ENVIRONMENTAL OVERLAY ZONE MAP CORRECTION PROJECT

Planning and Sustainability Commission
April 13, 2021 Work Session

Topic 1: Site Visit Corrections

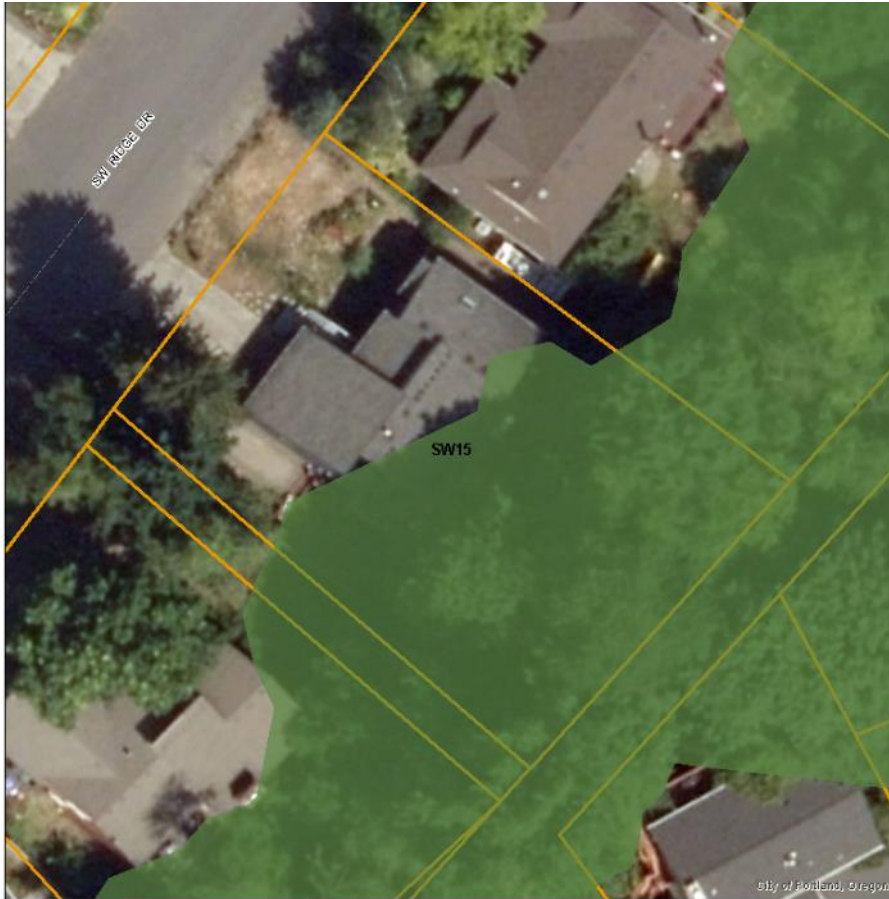
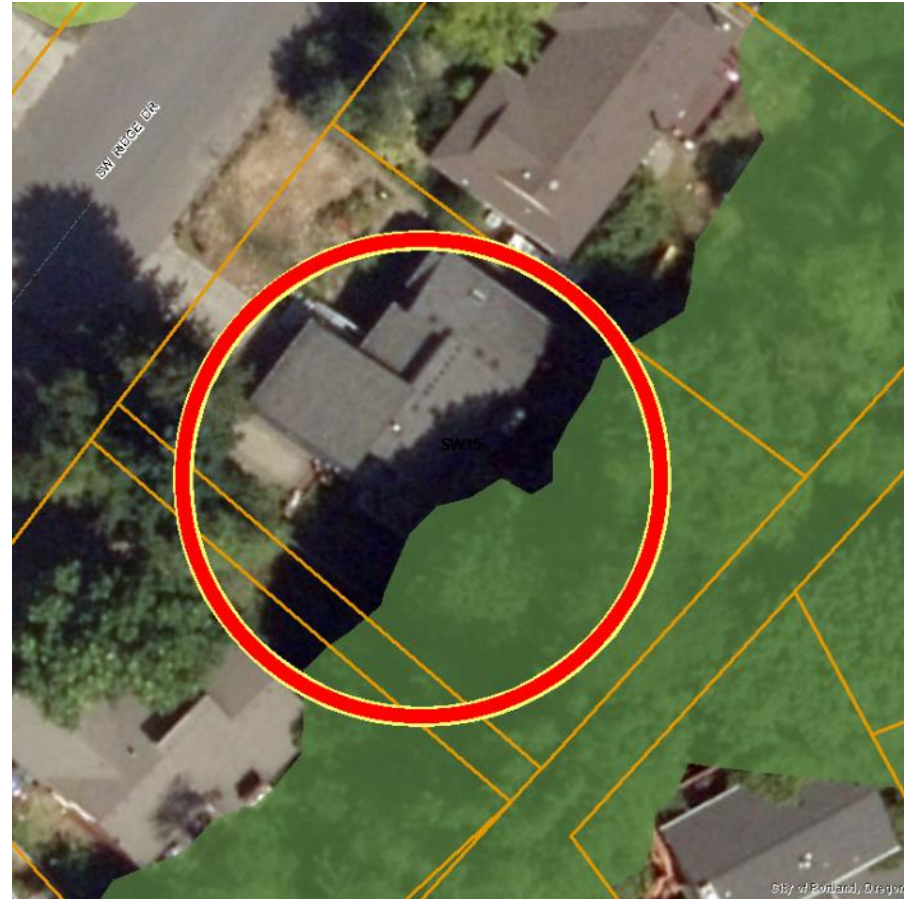
- Update the feature maps in the Natural Resources Inventory
- Then staff will apply the standard policy guidance
 - 'p' zones to streams, wetlands and riparian areas
 - 'c' zones to forests contiguous to waterbodies or on steep slopes
- Commissioners proposed amendments due to staff by April 16

I move to update the Natural Resources Inventory in Volume 3 to incorporate the results of the site visit feature map corrections found in PSC memos dated August 25, 2020, January 29, 2021 and April 2, 2021.

Topic 2: Audubon's Request

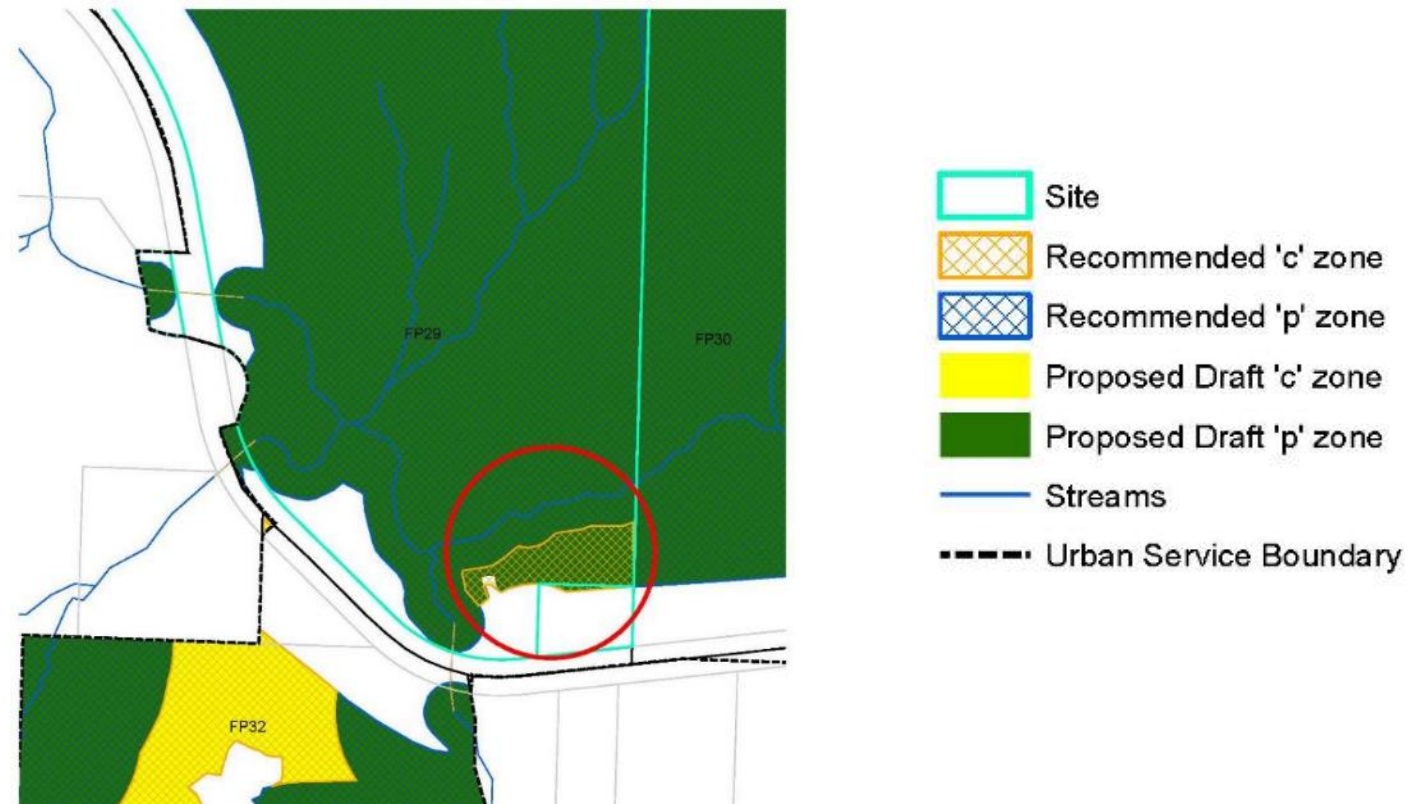
Testimony – *Apply a conservation 'c' zone instead of a protection 'p' zone to the forest canopy in the southern portion of the site near the care center.*

I move to apply the ezones as requested, reducing the level of protection for the southernmost stream from a 'p' zone to 'c' zone for the areas greater than 50 feet from the stream and to update the Volume 1 and Volume 2 to reflect the change.

Topic 3: OHSU's Request

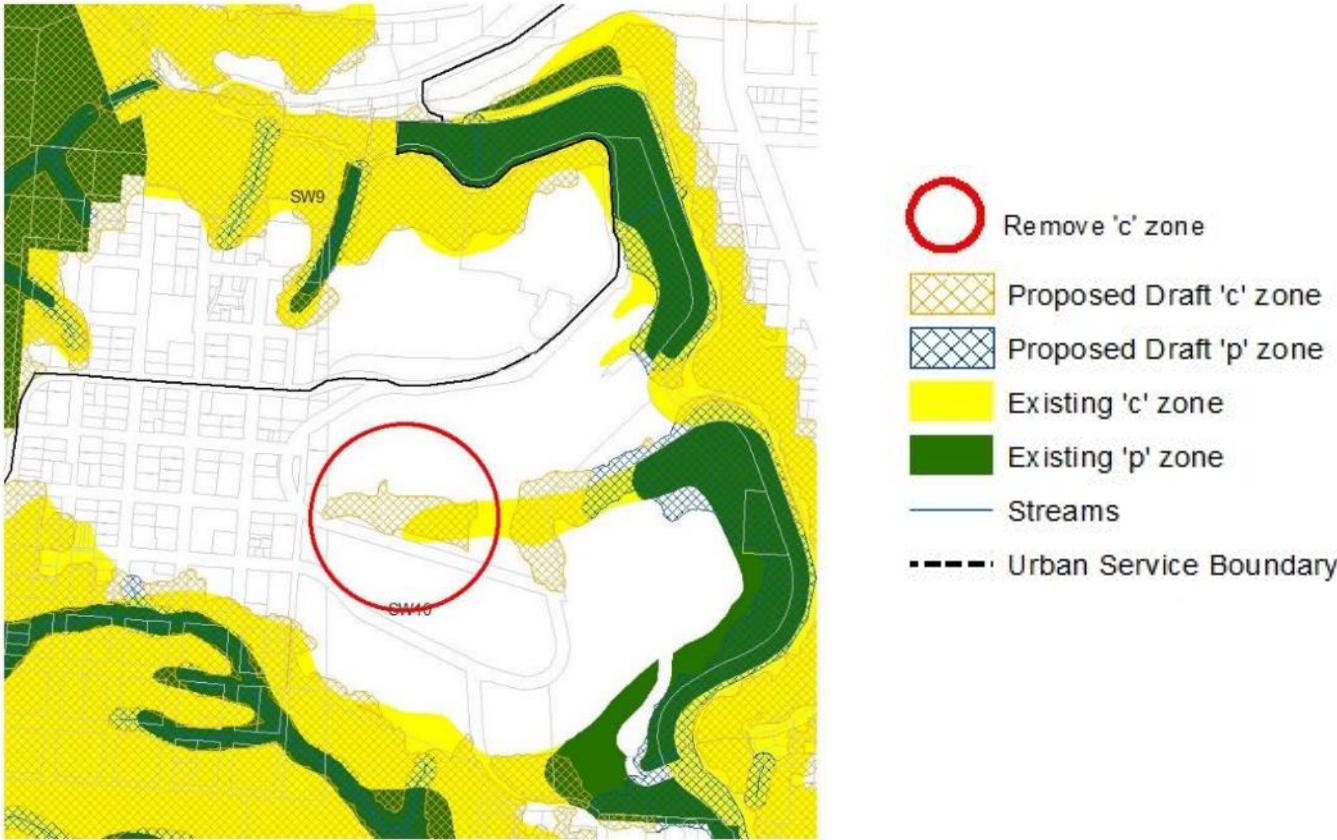
Testimony - *Do not apply an environmental overlay zone to the isolated patch of forest west of the Children's Hospital.*

I move to remove the 'c' zone, as requested, from the isolated forest patch west of the Children's Hospital and to update Volume 1 and Volume 2 to reflect the change.

Topic 7: Industrial and Employment Lands

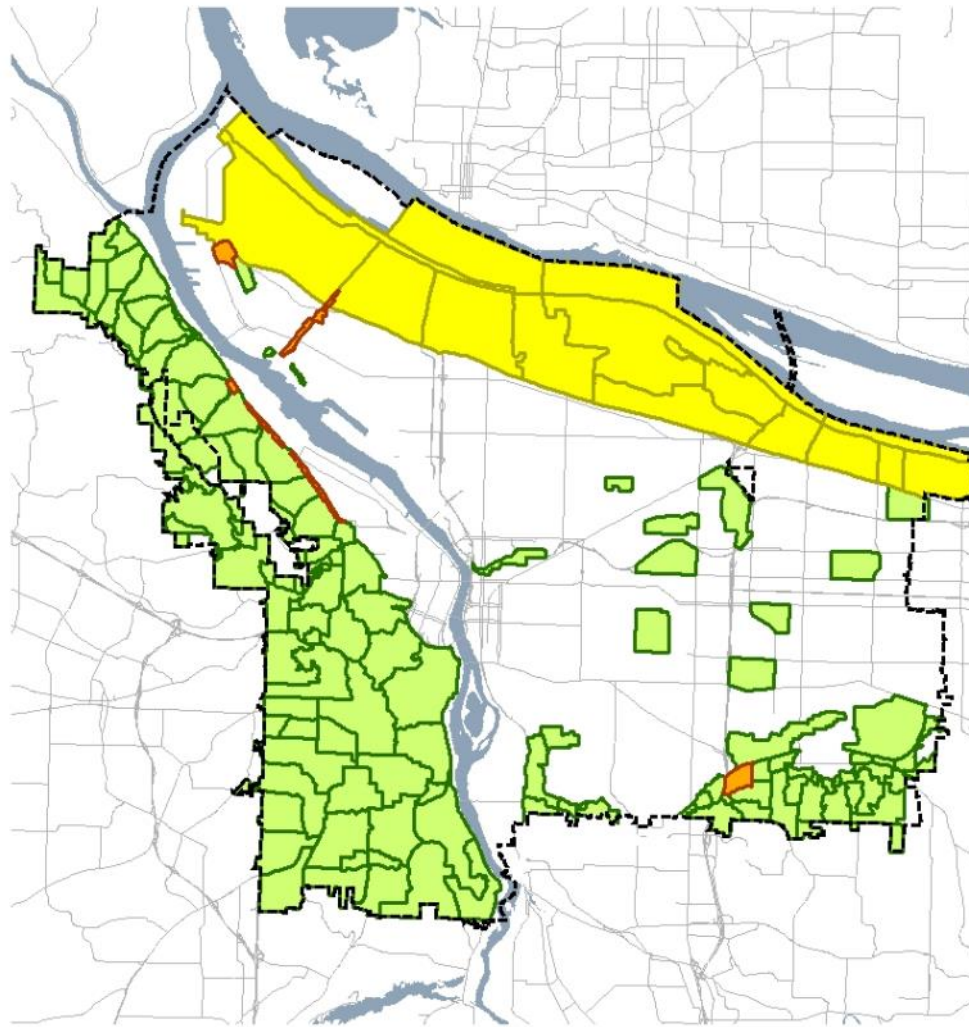
Changes to the coverage of environmental overlay zones on lands zoned for industrial or employment uses could impact Portland's industrial land capacity.

These impacts should be addressed through the Economic Opportunities Analysis.

I move to remove the areas shown in the map in Attachment 7 from the Ezone Project and address them in a future project.

Figure 430-1: Environmental Zone Subareas

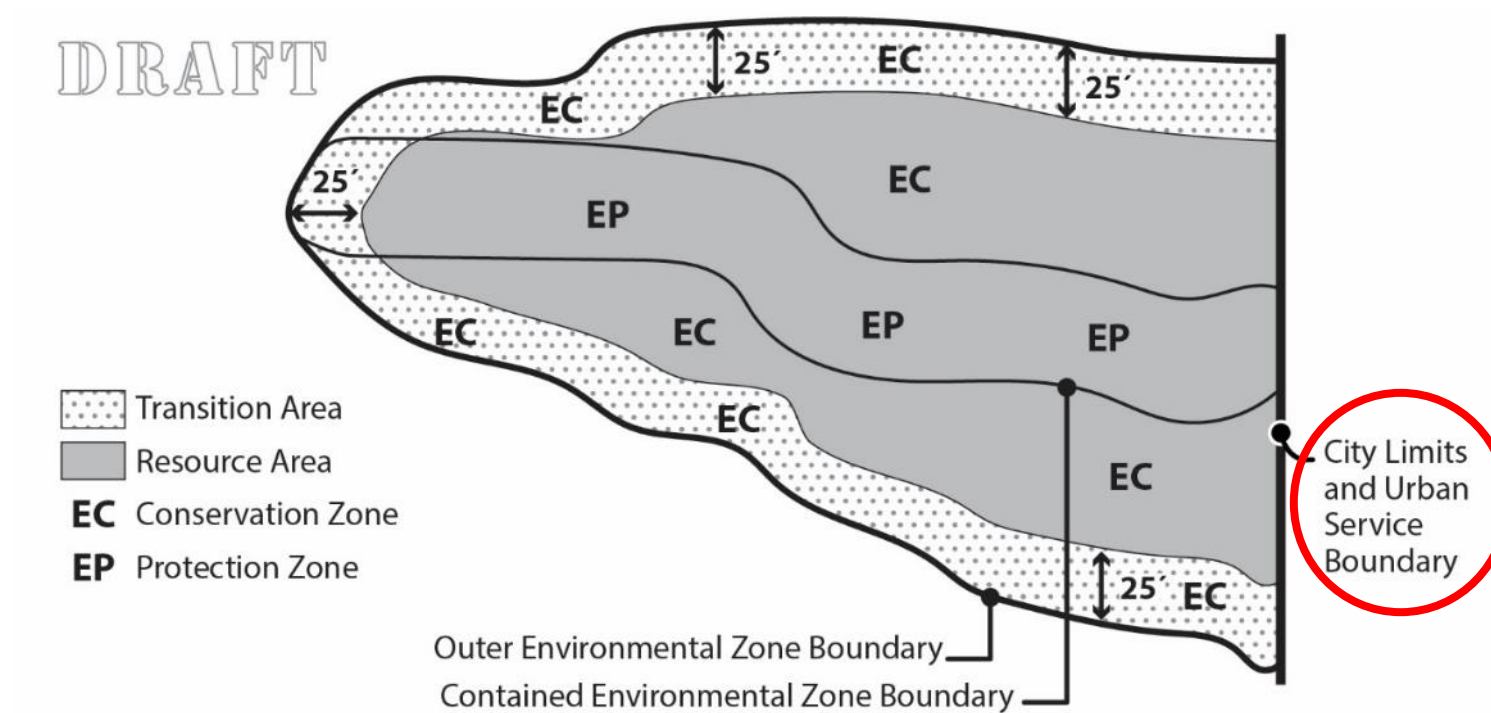
Code 33.430.050 and figure 430-1 explain how the transition area is measured and the relationship to the city limits.

BDS requested these amendments to codify that the Urban Service Boundary is treated the same as the city limits.

I move to amend zoning code 33.910.050, Subareas of Environmental Zones, and Figure 430-1, as shown in Attachment 11.
